Addendum

SPRINGS AT FREMAUX TOWN CENTER
SLIDELL, LA

PHILLIPS JOB NUMBER 1333104
ISSUE DATE 07/07/14
DRAWN BY/CHECKED BY ATL/DEB
DRAWING TITLE UNIT 2GC FLOOR PLAN, ELEVATIONS & DTLs.
SHEET NUMBER A4.2GC

UNIT 3GC
FLOOR PLAN,
ELEVATIONS & DTLs.
 SHEET NUMBER

ADA UNIT 3GCA - PLUMBING PLAN
1/4" = 1'-0"

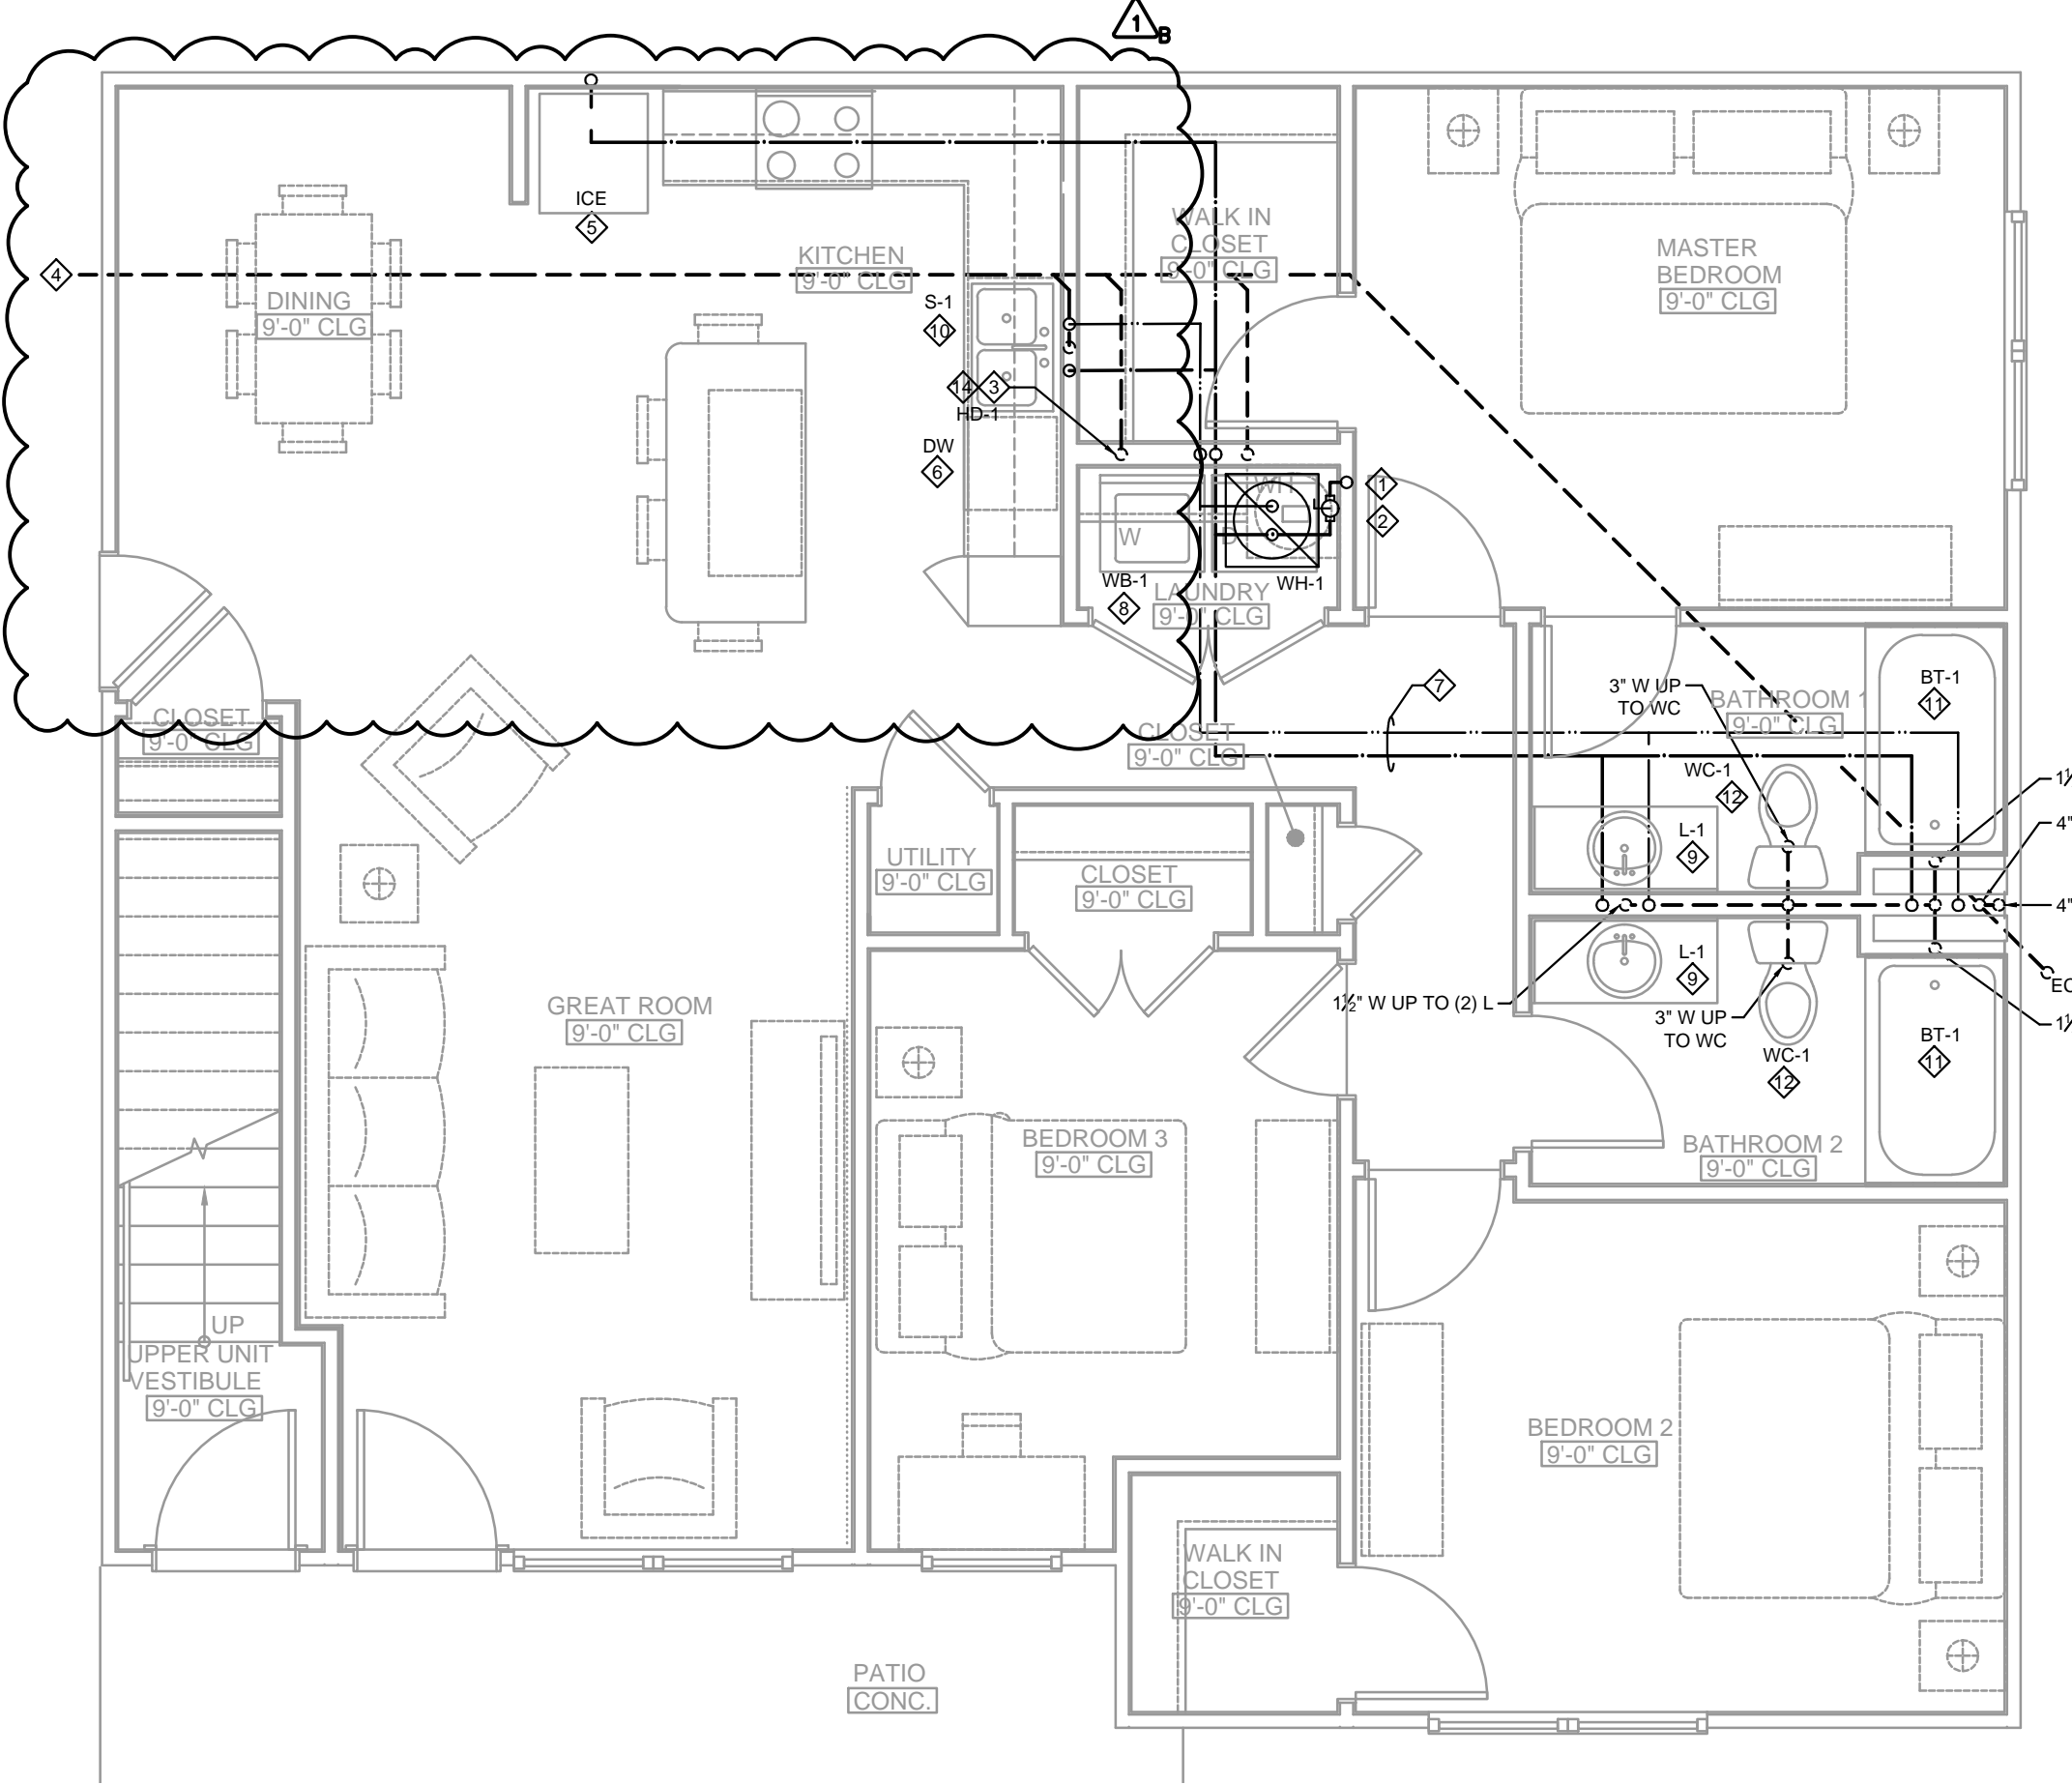
- A. REVISED NOTES.
- B. REVISED BASE.
- C. REVISED RISER DIAGRAMS
